Final Mitigated Negative Declaration/Initial Study, SCH 2023040473

This document constitutes the Final Initial Study / Mitigated Negative Declaration (IS/MND) for the Camino Pablo Single-Family Residential Subdivision, Rezone, General Plan Amendment, and Development Plan that consists of Major Subdivision application CDSD23-09646, Rezone application CDRZ23-03270, General Plan Amendment application CDGP21-00004, and Development Plan application CDDP23-03012, to allow development of the southern 7.9 acres of the 23.9-acre project site consisting of a residential subdivision of 13 single-family residences with attached accessory dwelling units (ADUs) incorporated into 11 of the residences. The remaining northern 16.0 acres of the site would remain as agricultural open space.

ALAMEDA WHIPSNAKE CRITICAL HABITAT

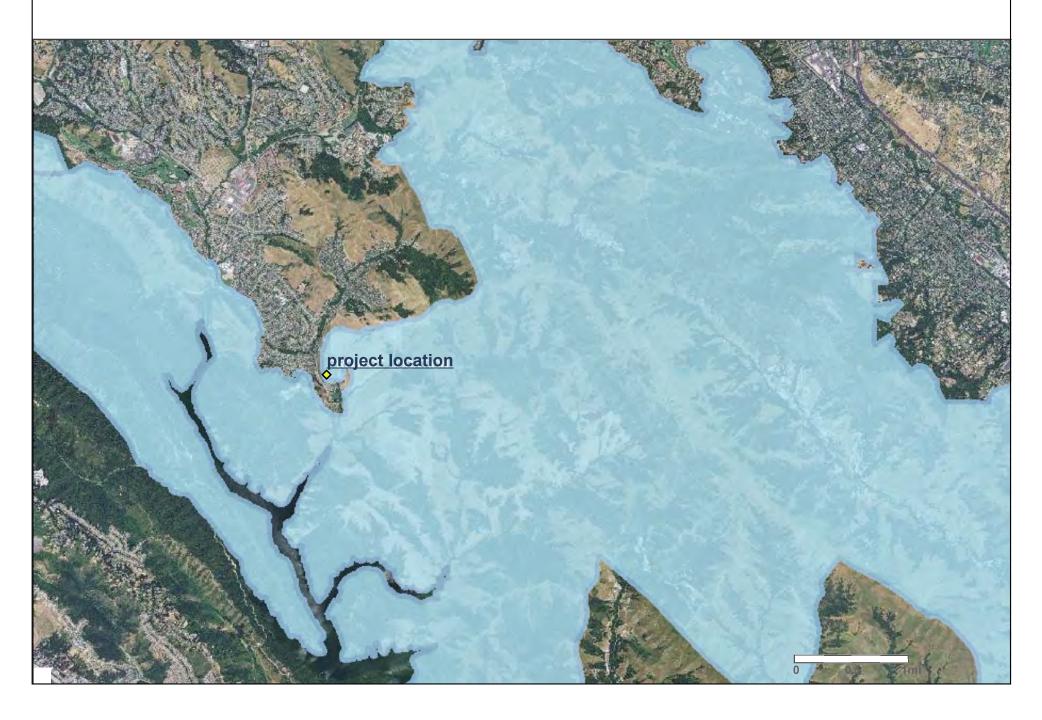
There are 24 Element Occurrences (EO) for Alameda whipsnake within 5 miles of this site. However, for simplicity, I've chosen to detail the 9 EOs that intersect a 3 mile buffer of the site of interest:

Local Responsibility Area Fire Hazard Severity Zones

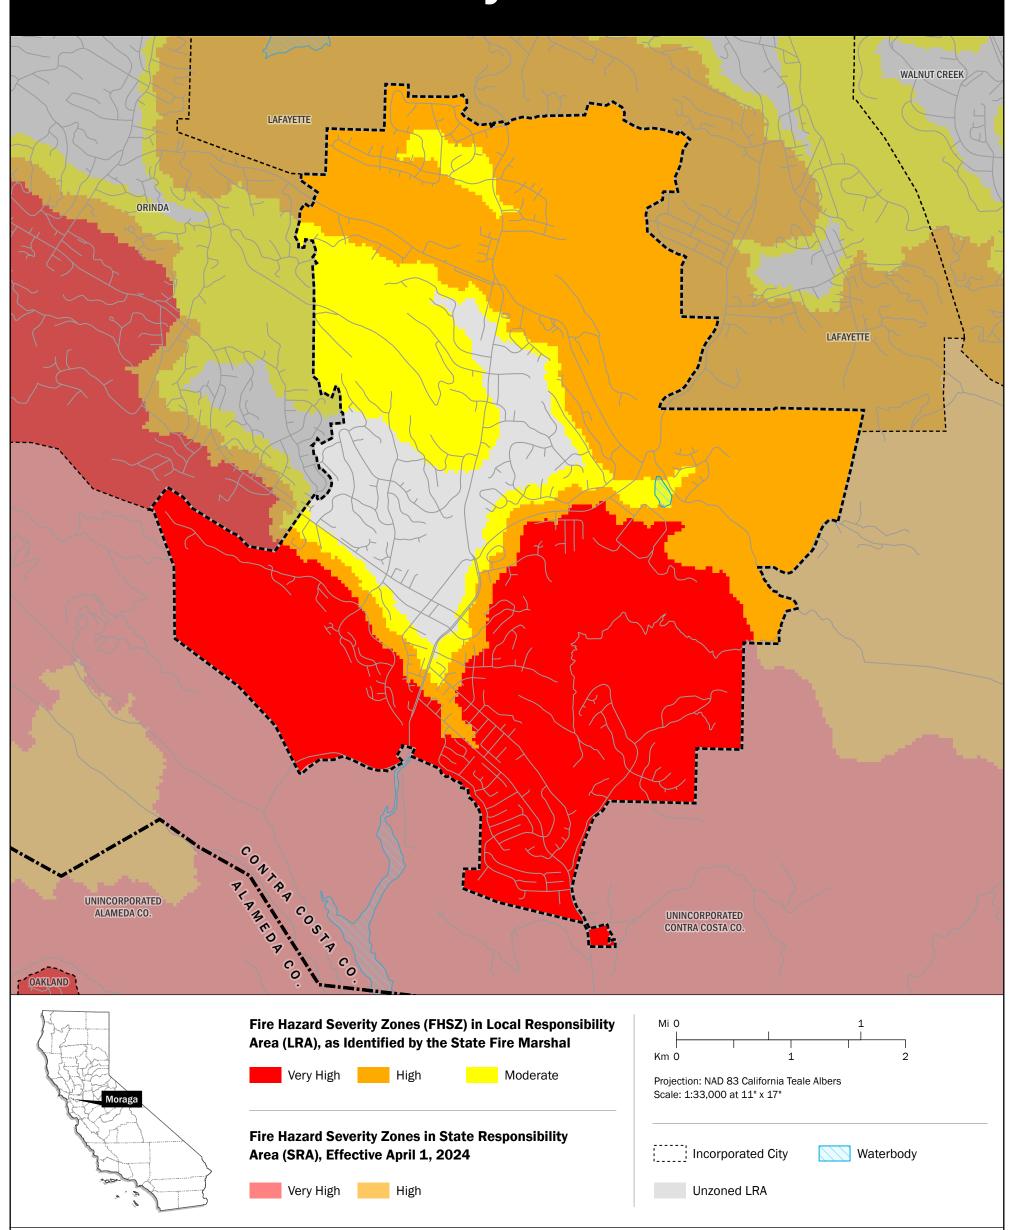
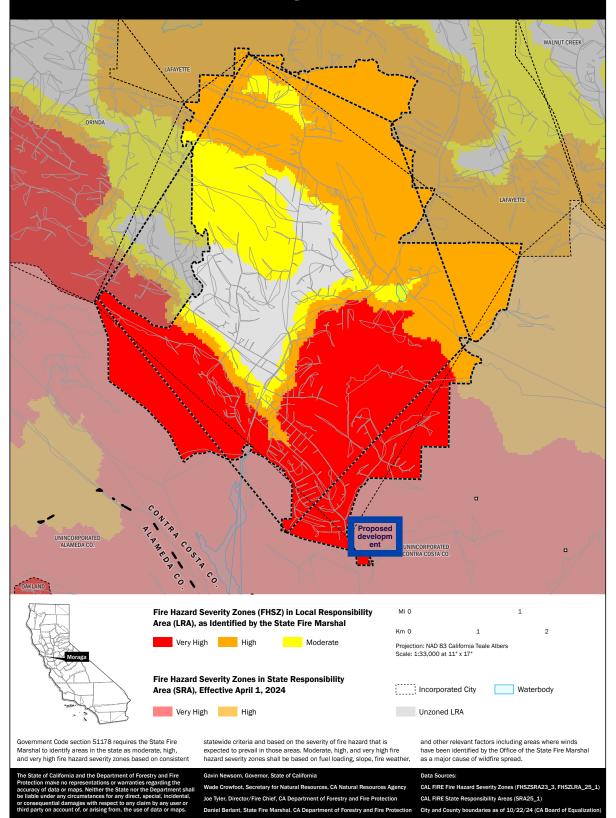
The Project may not be approved at all because it is inconsistent with the General Plan. As discussed above, The Project is inconsistent with the County's General Plan, Health and Safety Element, HS-P7.1, which flatly prohibits new residential development in Very High Fire Severity Zones. Since the Project is proposed to be constructed in a VHFSZ, it is inconsistent with the General Plan.

<u>Response</u>: Pursuant to the California Subdivision Map Act, section 66474.2, "the local agency shall apply only those ordinances, policies, and standards in effect at the date the local agency has determined the application is complete". The project was deemed complete on October 2, 2023, over a year before the adoption of policy HS-P7.1. Therefore, this policy shall not constitute a basis for denial of the project pursuant to the Subdivision Map Act. Also, see responses to comments 19.r (Wildfire) and 19.x (Public Services).
